11057 8TH AVE NE

DESIGN RECOMMENDATION #2

SDCI #3034765 // JANUARY 10, 2022

DEPARTURE REQUEST #1 SHOWING CURRENT DESIGN

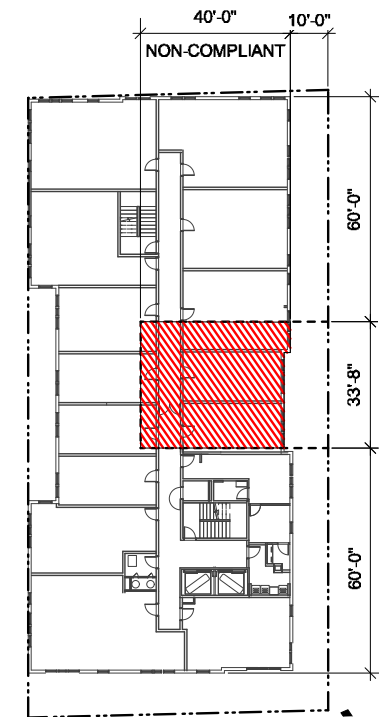
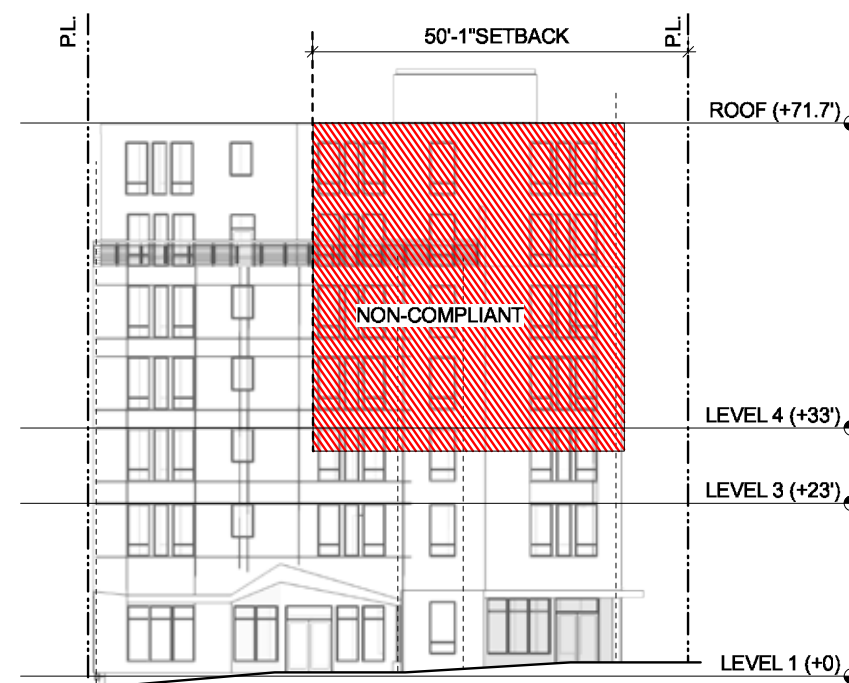
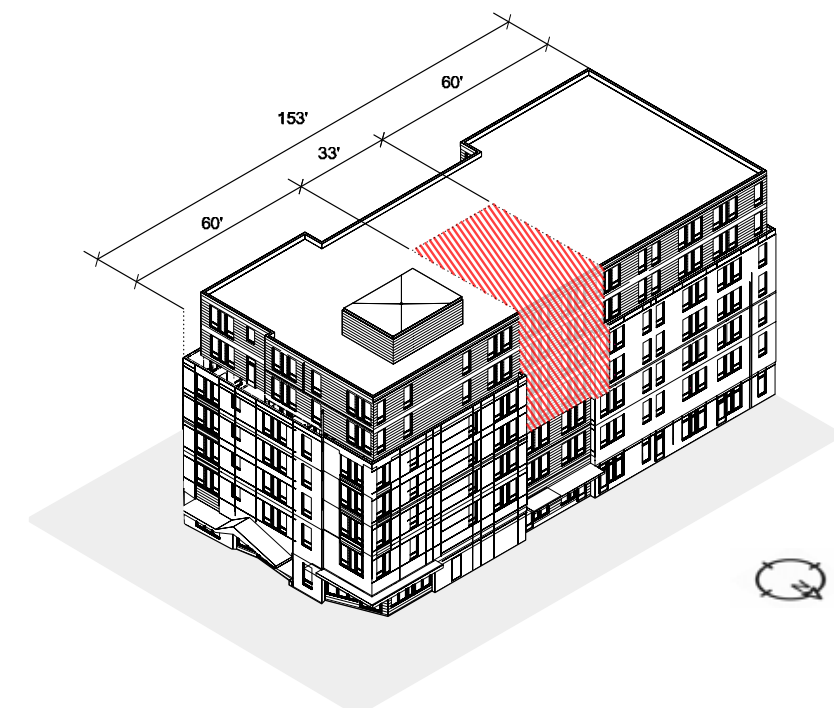
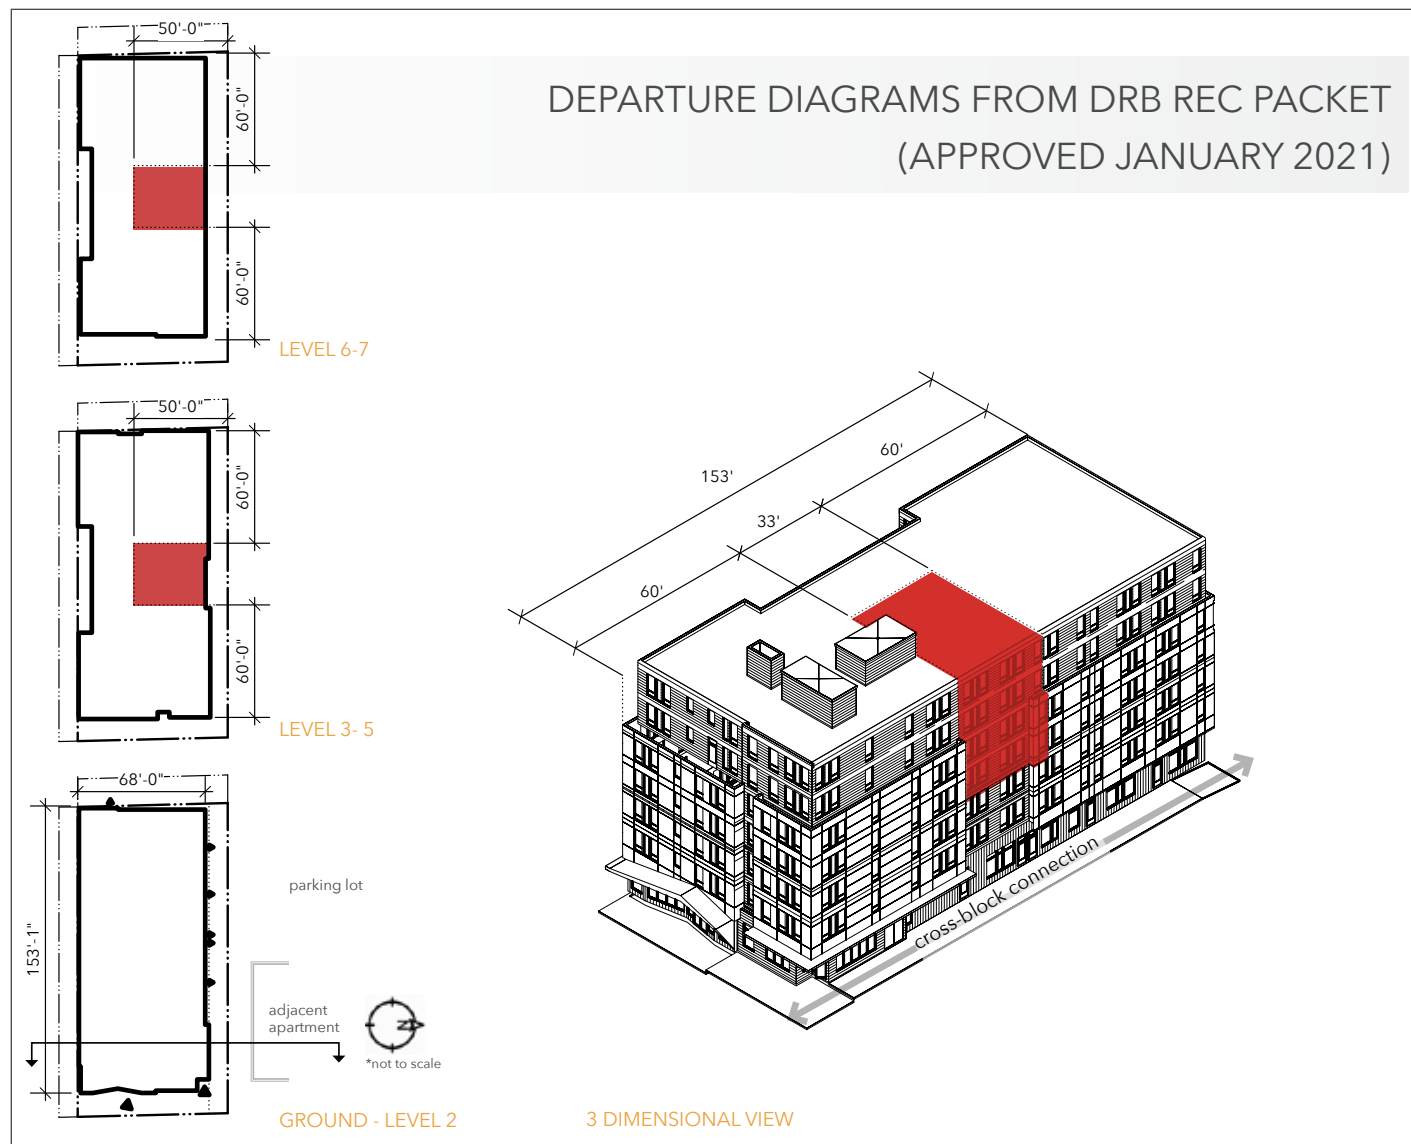
The Code requires the wall length to remain less than 80% of the length of the abutting lot line to maximum of 60 feet, where the building height exceeds 30 feet. The applicant proposes a building length of 153 feet along the north property line, which equals approximately 93.7% of the length of the abutting lot line. This requirement only applies to wall lengths adjacent to zone transitions.

The Board **unanimously recommended approval** of the requested departure, stating that the recommended condition for a simplified building massing, along with the design of the north walkway the zone transition design, will allow for a nuanced zone transition that does not require the significant massing moves required by the Northgate Overlay.

UPDATE FOR FINAL MUP DRAWINGS: Final design maintains the condition outlined in the DRB package; departure utilized as approved.

DEPARTURE REQUEST #4 SHOWING CURRENT DESIGN

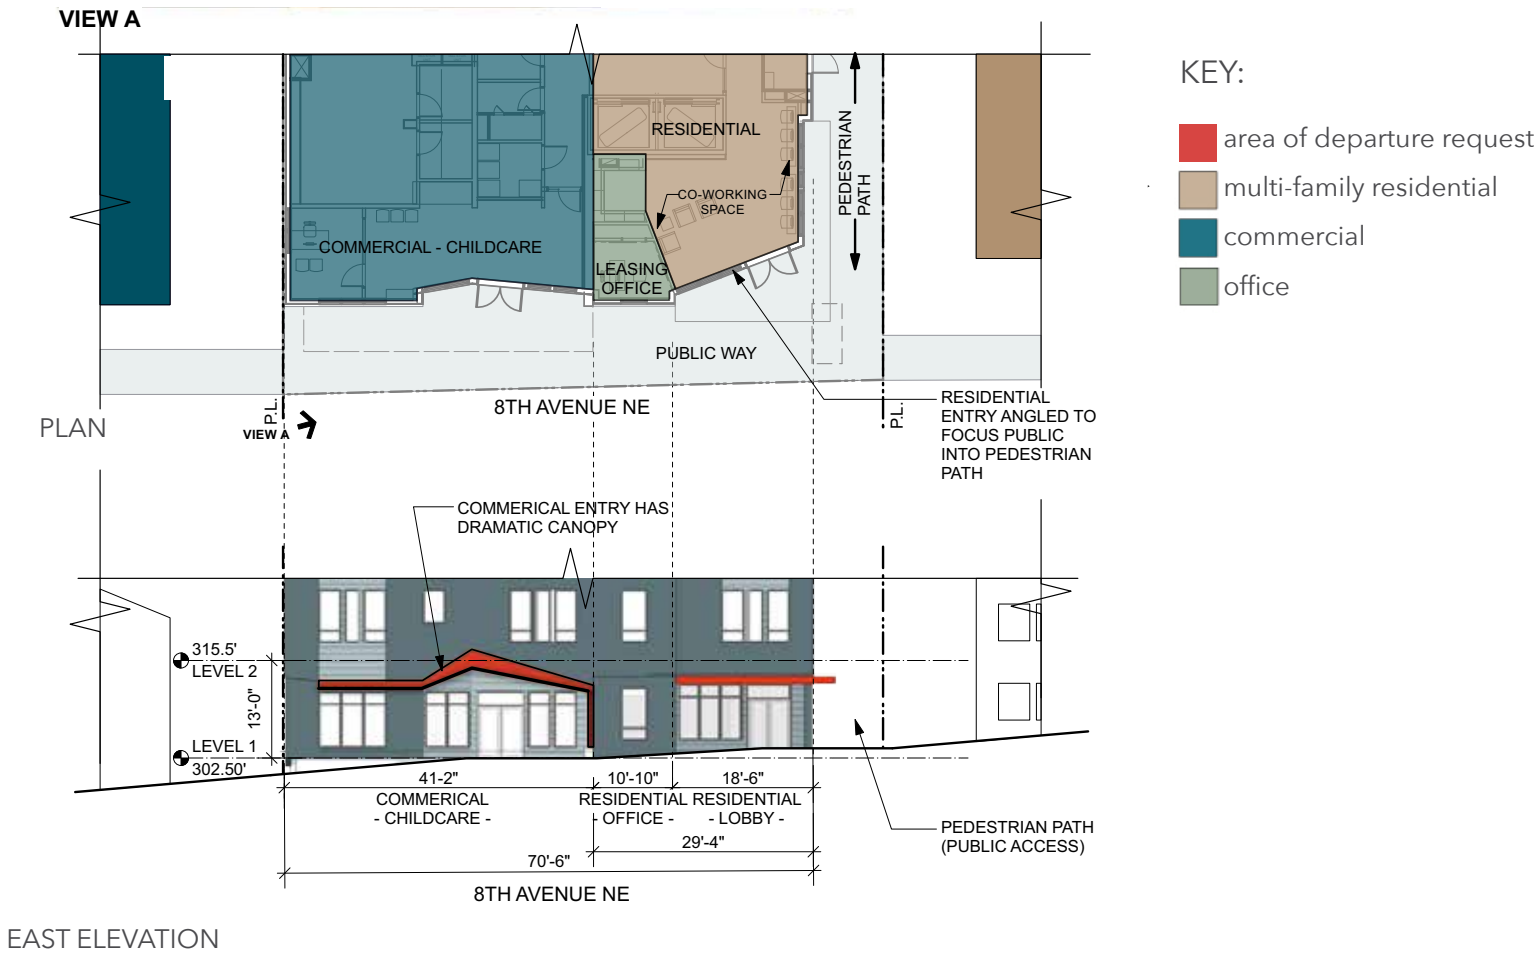
The Code limits residential uses to a maximum of 20% of the street-level street-facing façade. The applicant proposes a departure to allow the proposed residential use to occupy up to 42% of the street-facing façade to be occupied by a residential use.

The Board **recommended approval** of this special exception, stating that increased residential presence at ground level allows for a widened transition from the sidewalk frontage to the north walkway while also providing a ground-level residential transition to the adjacent multi-family residential building to the north.

UPDATE FOR FINAL MUP DRAWINGS: Final design maintains the condition outlined in the DRB package; Project team has applied for the special exception as required.

DEPARTURE REQUEST #2 SHOWING CURRENT DESIGN

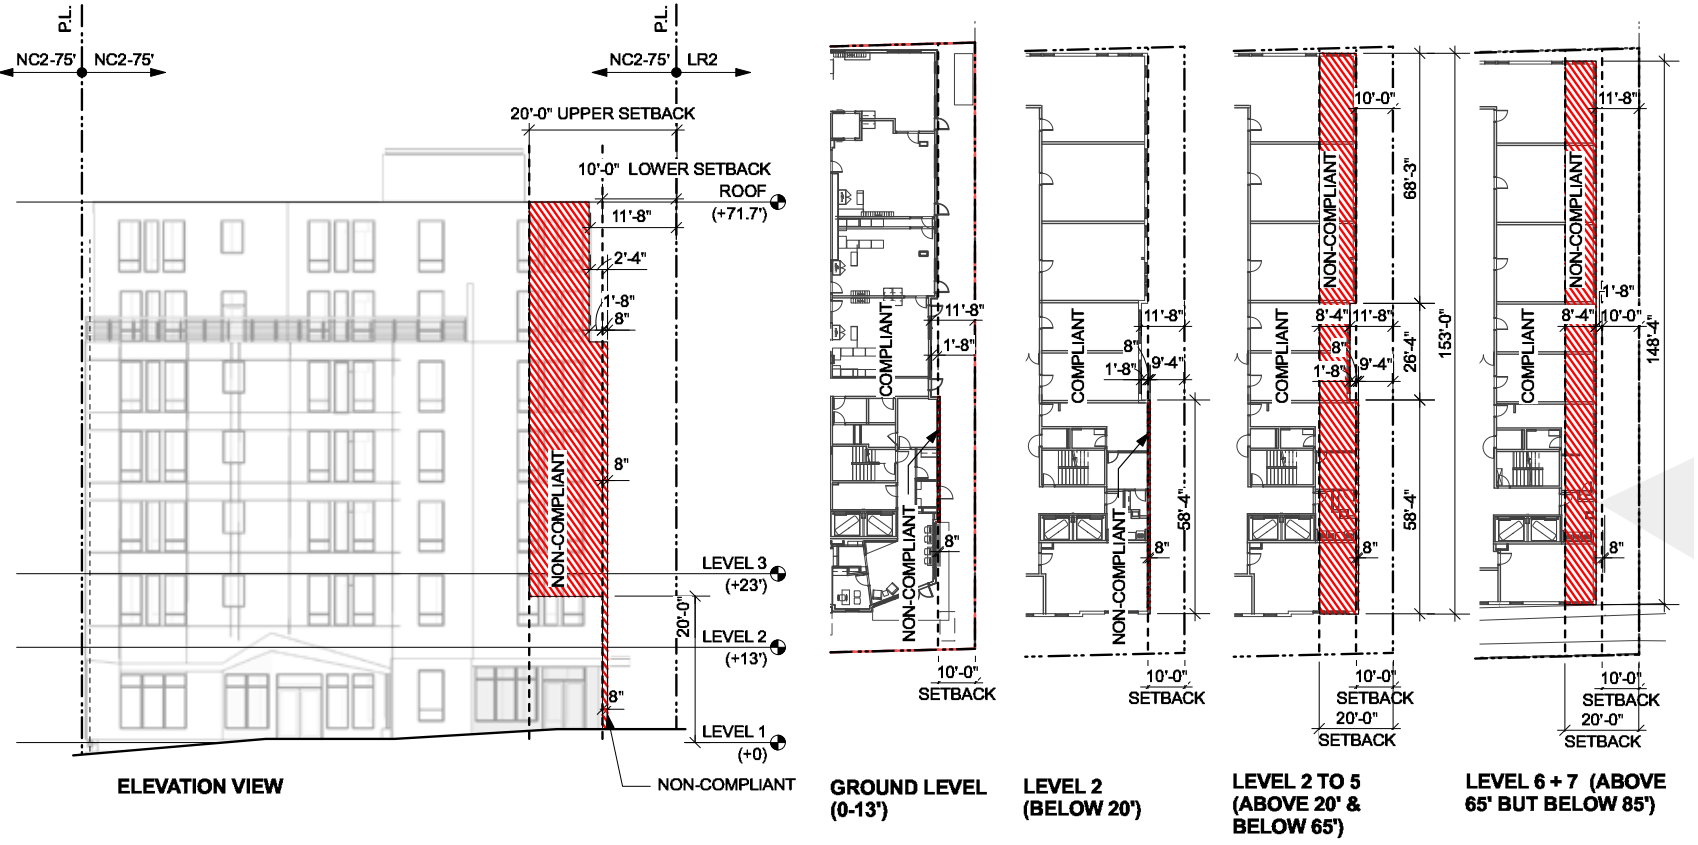
The Code requires a minimum setback of 20 feet for all portions of the structure exceeding 20 feet in height along a zone transition in the Northgate Overlay. The applicant proposes setbacks as short as 9 feet, 4 inches along the north property line. This requirement only applies to wall lengths adjacent to zone transitions.

The Board **recommended approval of the requested departure**, stating that the departure request is needed to allow for the simple massing concept intended by the applicant. The Board stated that the simple massing concept will appropriately relate to surrounding context, including the residential zone and existing buildings to the north. The architectural relationship combined with the placement of a walkway connection on the north side will serve as an effective zone transition without the required upper-level setbacks. The Board recommended a condition related to this departure request to utilize the minimum setback intrusion necessary to meet guidance related to massing.

UPDATE FOR FINAL MUP DRAWINGS: Final design could not substantially reduce the setback intrusion and maintain interior program and the overall condition related to massing; departure utilized in materially same form as approved.

DEPARTURE REQUEST #3 SHOWING CURRENT DESIGN

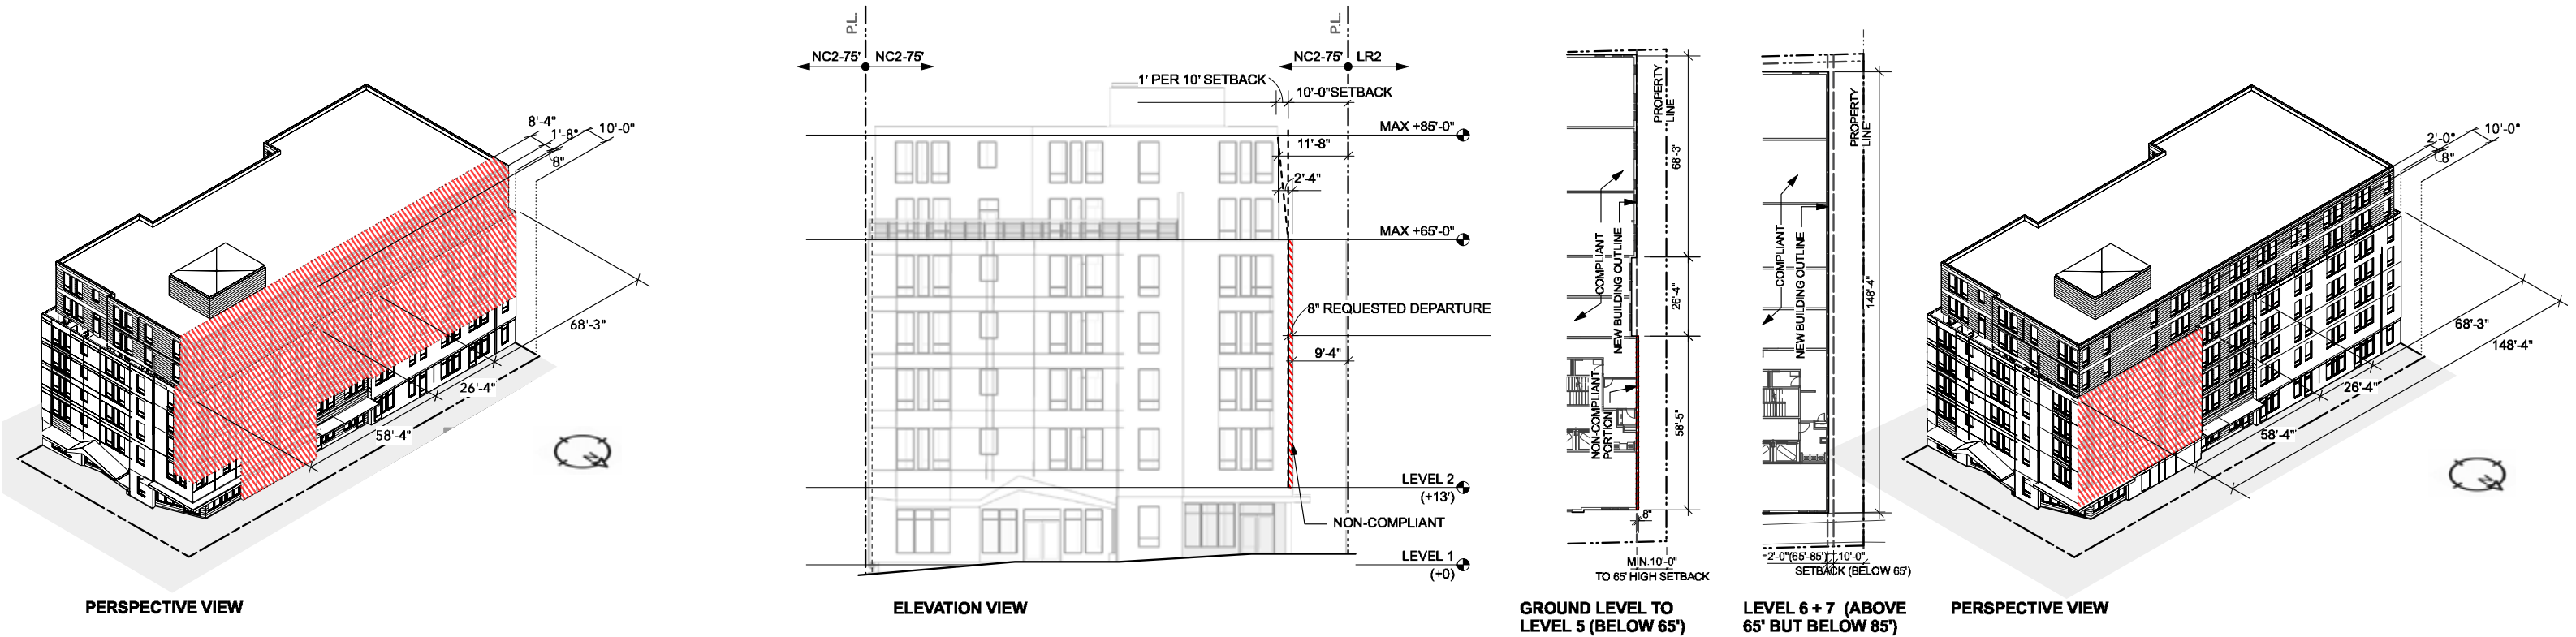
The Code requires a minimum setback of 10 feet for all portions of the structure between 13 and 65 feet in height and an additional 1 foot of setback for every additional 10 feet of façade height above 65 feet. The applicant proposes setbacks as short as 9 feet, 4 inches along the north property line above the 13 foot height. This requirement only applies to wall lengths adjacent to zone transitions.

The Board recommended approval of the requested departure, stating that the departure request is needed to allow for the simple massing concept intended by the applicant. The Board stated that this massing concept will appropriately relate to surrounding context, including the residential buildings to the north. The architectural relationship combined with the placement of a walkway connection on the north side will serve as an effective zone transition without the required upper-level setbacks. The Board recommended a condition related to this departure request to utilize the minimum setback intrusion necessary to meet guidance related to massing.

UPDATE FOR FINAL MUP DRAWINGS: Final design could not substantially reduce the setback intrusion and maintain interior program and the overall condition related to massing; departure utilized in materially same form as approved.

LEVEL 6 PLAN, NON-COMPLIANT AMENITY SPACES

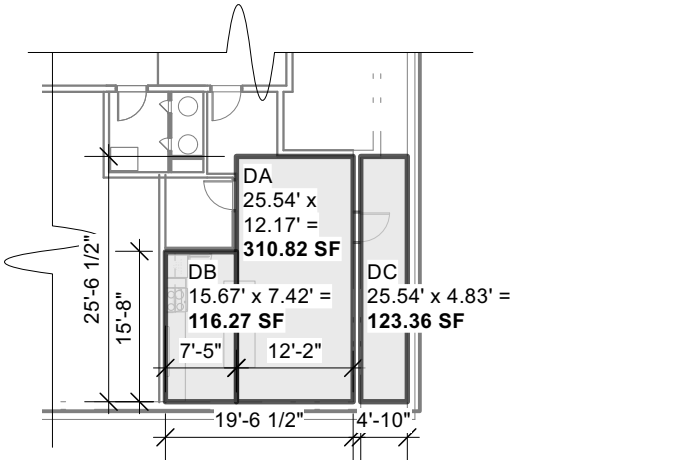
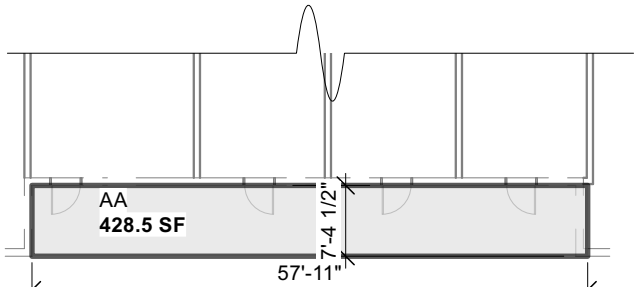
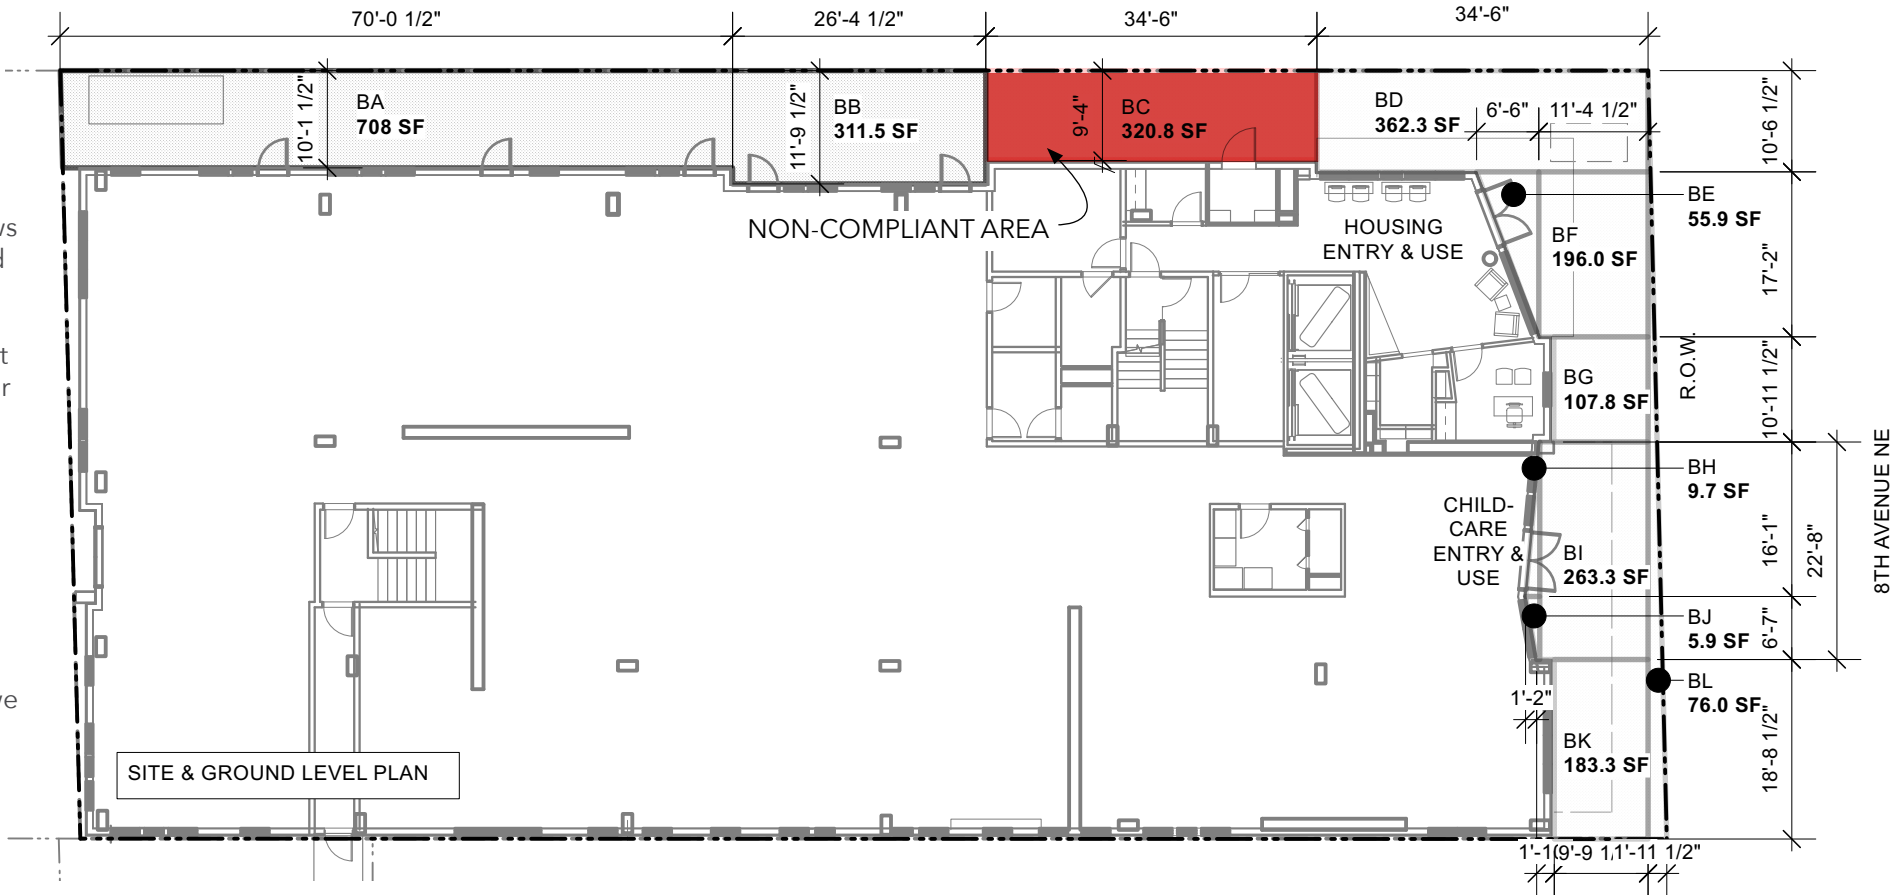
Our required amenity space is 2,982.5 SF.
We have 2,709 SF of Compliant SF.
We are only short by 273.5 SF (9 % of total)
The “non-compliant” area (labelled BC) is 320.8 SF
It is required to be 10’ wide, but is only 9’-4” wide.
We would not be short amenity if the 10’ requirement is waived (we are only 8” short).

When we made the design changes to bring the building ‘down to grade’ and better align windows and doors, it resulted in a 34.5’ section of the north pedestrian path not counting towards required residential amenity area as it 8” less than the 10’ wide requirement (see area highlighted in red in visual to right). We lose 320 sf against 274 sf still required, even though the area is contiguous to allowed sections and no less usable. We believe we meet the intent of providing amenity space at this project - in addition to the rest of the pedestrian path and private decks along the second floor (which all meet code standards), there is also a community room at level 6 with a kitchen, seating area and outdoor deck, and the adjacent 10,600 sf pocket park that the pedestrian path leads to (each which do not meet code specific standards as interior or adjacent spaces)

This change came about as an unintended consequence of the design changes requested at DRB. We believe the changes we made result in a building that better meets the DRB conditions. If we shift the wall back to gain the 8” in that location, we go back to 4 plane changes on that elevation instead of 2. We cannot shift the entire plane back 8” without completely compromising a line of units and redesigning the residential stacks. As a privately financed workforce housing building, we can not afford to lose residential units.
